# City of Corpus Christi

### Planning Commission

Wednesday, January 11, 2023

**TECHNICAL REVIEW PLAT REQUIREMENTS  
REGULAR PLANNING COMMISSION MEETING  
January 11, 2023**

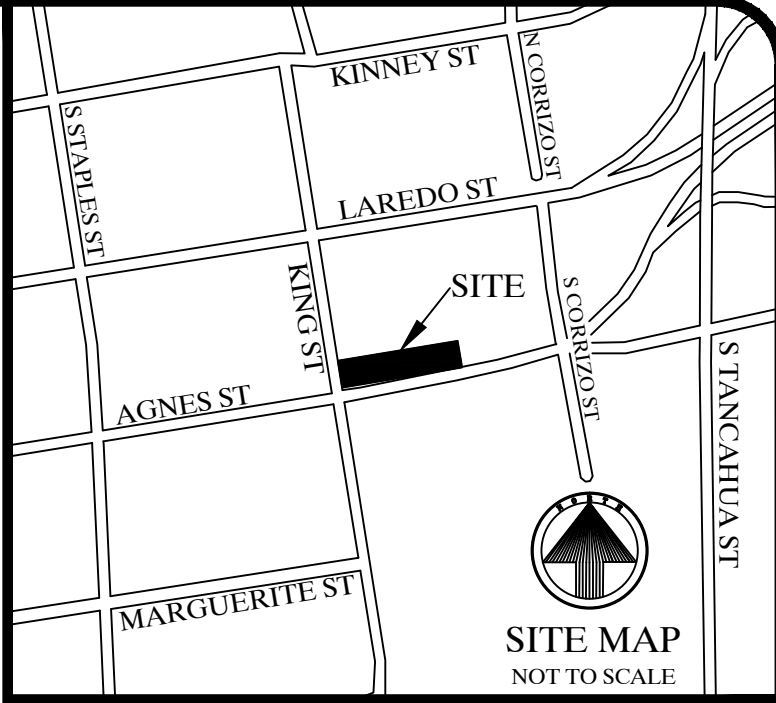
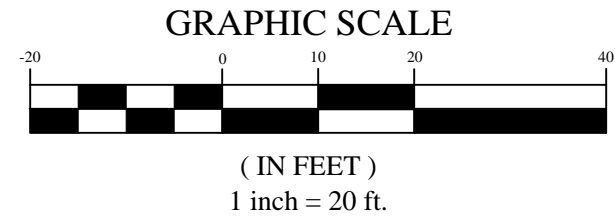
GIS						
No.	Sheet	Comment	Applicant Response	Staff Resolution	Applicant Response	Staff Resolution
1	Plat	Plat closes to acceptable engineering standards. (TSPS Manual of Practice Appendix A, Condition 3; Suburban Traverse Error of Closure)	Ok	Addressed		
2	Plat	Label the complete and correct legal description of the adjacent properties.	Updated adjoined info	Addressed		
LAND DEVELOPMENT						
No.	Sheet	Comment	Applicant Response	Staff Resolution	Applicant Response	Staff Resolution
1	Plat	Sidewalk required along King Street. A wavier may be submitted for the sidewalk.	will construct sidewalk	Addressed		
2	Plat	Agnes street is designated A2 on the UTP. A 100' ROW is required with half (50') being required for this plat.	Update ROW	Addressed		
3	Plat	Provide adjacent properties legal descriptions and acreage amounts.	Updated adjoiner info	Addressed		
4	Plat	Remove adjacent owners names from plat and provide correct legal descriptions.	Updated adjoiner info	Addressed

5	Plat	Depict Y.R. for zoning district RM-3 Front Y.R. is 15' along Agnes and 20' along King.	Added 20' and 15' Y.R.	Addressed		
6	Plat	Depict 10' U/E along Agnes St.	Added 10' U.E.	Addressed		
7	Fees	Commercial or etc. Water Acreage Distribution Fees: .26 Ac. x 1,741.19 = \$452.71	Ok	Prior to recordation		
8	Fees	Commercial or etc. Wastewater Acreage Fees: .26 Ac. x 1,900.91= \$494.24	Ok	Prior to recordation		
9	Fees	Pro Rata Fees Water: 225 L/F x 12.74 = \$2,866.50	Ok	Prior to recordation

DEVELOPMENT SERVICES ENGINEERING						
No.	Sheet	Comment	Applicant Response	Staff Resolution	Applicant Response	Staff Resolution
1	Plat	Agnes is designated as an A2 with a 100' ROW. Update ROW from 37.5' to 50'.	Updated ROW	Accepted		
2	Utility Plan	No comments.	No response	Accepted		
UTILITIES ENGINEERING						
No.	Sheet	Comment	Applicant Response	Staff Resolution	Applicant Response	Staff Resolution
1	Plat	No water construction is required.	Ok	Addressed		
2	Plat	No wastewater construction is required.	Ok	Addressed

# FINAL PLAT SMT CORPUS

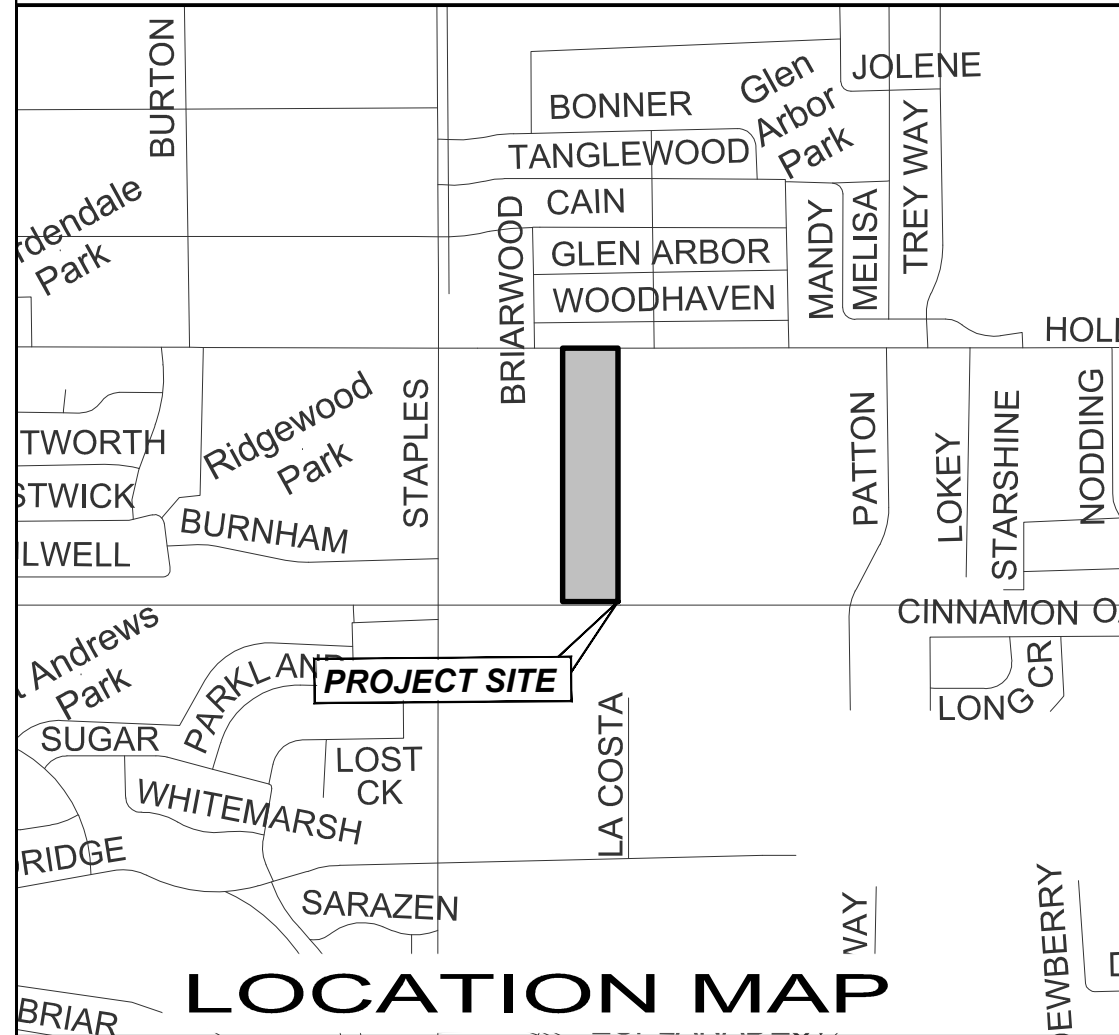
GIS					
No.	Sheet	Comment	Applicant Response	Staff Resolution	Applicant Response
1	Plat	Plat closes to acceptable engineering standards. (TSPS Manual of Practice Appendix A, Condition 3; Suburban Traverse Error of Closure)		Addressed	
2	Plat	Lot and block number is required for platted area.	There is only 1 Lot therefore no need to have a block No.	Addressed	
LAND DEVELOPMENT					
No.	Sheet	Comment	Applicant Response	Staff Resolution	Applicant Response
1	Plat	Please revise plat as per the Platting - Land Development templates found on the DS website.	Done. See revision to plat.	Addressed	
2	Plat	Provide legal description for lots being platted.	Done. See revision to plat.	Addressed	
3	Plat	Change PC chairman name to Kamran Zarghouni	Done. See revision to plat.	Addressed	
4	Plat	Change Dev. Ser. Engineer name to Bria Whitmire P.E., CFM, CPM	Done. See revision to plat.	Addressed	
5	Plat	Depict and label tracts, lots, and easements (U.E., DE, etc.) on the plat. Provide a 10' UE along Holly Road.	Done. See revision to plat.	Addressed

6	Plat	Provide the square footage for each tract or lot under the Lot label.	Done. See revision to plat.	Addressed	
7	Plat	Depict yard requirements along Holly Road and other road on the plat as per the zoning district. A street name may need to be labeled if there has not been a recording showing a named street.	Done. See revision to plat.	Addressed	
8	Plat	Remove the elevations from the plat.	Done. See revision to plat.	Addressed	
9	Plat	Change sheet numbers to read 1 of 1 (if plat is one page).	Done. See revision to plat.	Addressed	
10	Plat	In the ownership certification, SMT Corpus is stated as owner, the current owner is Bells of Holly LLC as per the submitted deed. Please correct the ownership or provide updated Deeds.	Name of the Plat is SMT Corpus Land. Landowner is correctly depicted in the signature line.	Addressed	
11	Infor.	What type of development is going onto the property?	Stand Alone Battery Energy Storage	Addressed

12	Plat	Mobility plans call for Multi-use Trail along rear of property.	Public sidewalk easement added to plat. SMT Energy plans to apply for a Deferment Agreement.	Prior to recordation.	
13	Plat	Delineate the south boundary without the Drainage Easement and correct the square footage to the Lot label only. Provide a plat note, "Total square footage with storm dedication is 6.881 acres.	Lot is shown as entire property owned by Bells of Holly. Note depicting net acreage is located on Note #11.	Addressed	
14	Fees	Commercial or etc. Water Acreage Distribution Fees: 7.08 Ac x 1,741.19 = \$12,327.63	Thank you	To be paid prior to recordation	
15	Fees	Commercial or etc. Wastewater Acreage Fees: 7.08 Ac. x 1,900.01 = \$13,458.44	Thank you	To be paid prior to recordation	
PLANNING/Environment & Strategic Initiatives (ESI)					
No.	Sheet	Comment	Applicant Response	Staff Resolution	Applicant Response
1	Plat	No comment recieved.

DEVELOPMENT SERVICES ENGINEERING						
No.	Sheet	Comment	Applicant Response	Staff Resolution	Applicant Response	Staff Resolution
1	Plat	Change the name of the engineer from Gabriel Hinojosa, P.E. to Bria Whitmire, P.E., CFM, CPM.	Redundant with comment above	Accepted.		
2	Plat	Public Improvements Plans are required for wastewater; submit a .PDF copy of proposed Public Improvements along with a title sheet to Publicimprovmnts@CCTexas.com for review and approval prior to Final Plat Recordation, UDC 8.1.3.A	No wastewater required for this project. No offices or restrooms to be on site. This is an unmanned battery energy storage facility.	See wavier		
3	Utilities	Please provide details that show how they are going to connect to the city main or write a comment referring the city of corpus Christi pertaining standard. Standard Specifications <a href="https://www.cctexas.com/promo/standard-specifications">https://www.cctexas.com/promo/standard-specifications</a> Standard Details <a href="https://www.cctexas.com/promo/standard-details">https://www.cctexas.com/promo/standard-details</a>	See Tapping Sleeve and Valve Installation Detail.	Accepted.

4	Utilities	Label 8" waterline as private with valve at property line. A dead end line longer than 100' requires to be looped to ensure water flow and avoid stagnation that can cause disinfection issues. Confirm layout with Utilities.	No wastewater required for this project. No offices or restrooms to be on site. This is an unmanned battery energy storage facility.	See wavier		
5	Utility Plan	The Utility Plan indicates an 8" water line will cross Holly in order to connect to another 8" water line. Crossing Holly is not allowed and there is a 12" water line in front of the lot that could possibly be tapped into, confirm with CCW	Please see revision indicating connection to new 12" water line.	Accepted.		
6	Utility Plan	Holly Road is an 95 ft arterial road. Crossing of Arterials to connect is not allowed. The wastewater line will need to be developed along the front of the lot as part of the platting process and an alternative path of connection to the wastewater system will be necessary. Confirm layout with Utilities.	No wastewater required for this project. No offices or restrooms to be on site. This is an unmanned battery energy storage facility.	See wavier

7	Utility Plan	Per Section 3.04 b. d & e of the Infrastructure Design Manual, the minimum pipe size for storm sewer pipe is 18 inches. Confirm the 8" SD is to control max flow.	8" is required to control the max flow. Still shown as 8".	Accepted.		
8	SWQMP	Please submit a Storm Water Management Plan (SWQMP) civil drawing sheets separately the ones on the report Appendix B were very blurry and could be read.	SWQMP still subject to change because site plan has not been finalized. Suggest to submit civil plans at a later date due to potential equipment location changes.	Accepted.		
9	SWQMP	Storm water detention facilities shall be designed to release the post-development storm water runoff from a site at a controlled rate, which does not exceed the pre-developed peak runoff rate. IDMC 3.05.b Pre-Developed Peak Runoff	Project is using a reduced outfall pipe size (8" instead of 18") to control the max flow rate and ensure water runoff does not exceed the pre-developed peak runoff rate. See revision to SWQMP.	Accepted.

10	SWQMP	Provide contours or flow direction arrows to document pre-, and post- Development flow patterns (onsite and offsite to the final receiving waters). And state how off-site flow contributions are to be managed. (MC - 1002, 1003, UDC 8.2.8.B)	See additional sheets showing contours and flow direction arrows. Project is using a reduced outfall pipe size (8" instead of 18") to control the max flow rate and ensure water runoff does not exceed the pre-developed peak runoff rate. See revision to SWQMP.	Accepted.		
11	SWQMP	Provide a brief description of the Project to include current land use, proposed land use and density, existing drainage structures on or near the site and proposed drainage structures to be constructed with the development. (MC14-1002)	Please see updated description in Section 1.0, Page 6.	Accepted.		
12	SWQMP	Cite the source and rational for selection of rainfall intensity and runoff coefficient values. (MC 14-1002)	Done. See revision to plat.	Accepted.

UTILITIES ENGINEERING						
No.	Sheet	Comment	Applicant Response	Staff Resolution	Applicant Response	Staff Resolution
1	Plat	No water construction is required for platting. There is an existing 12" PVC water line that extends along the south side of Holly Rd and fronting the subject property. Water service connection should be made to the 12" line and not across the street as shown on the Utility Layout.	Please see revision indicating connection to new 12" water line.	Addressed		
2	Plat	Wastewater construction may be required for platting (UDC 1.2.1.D & 8.2.7; Wastewater Collection System Standards). Nearest point of connection appears to be an 8" sanitary sewer line crossing Holly Rd at Briarwood St.	No wastewater required for this project. No offices or restrooms to be on site. This is an unmanned battery energy storage facility.	See wavier
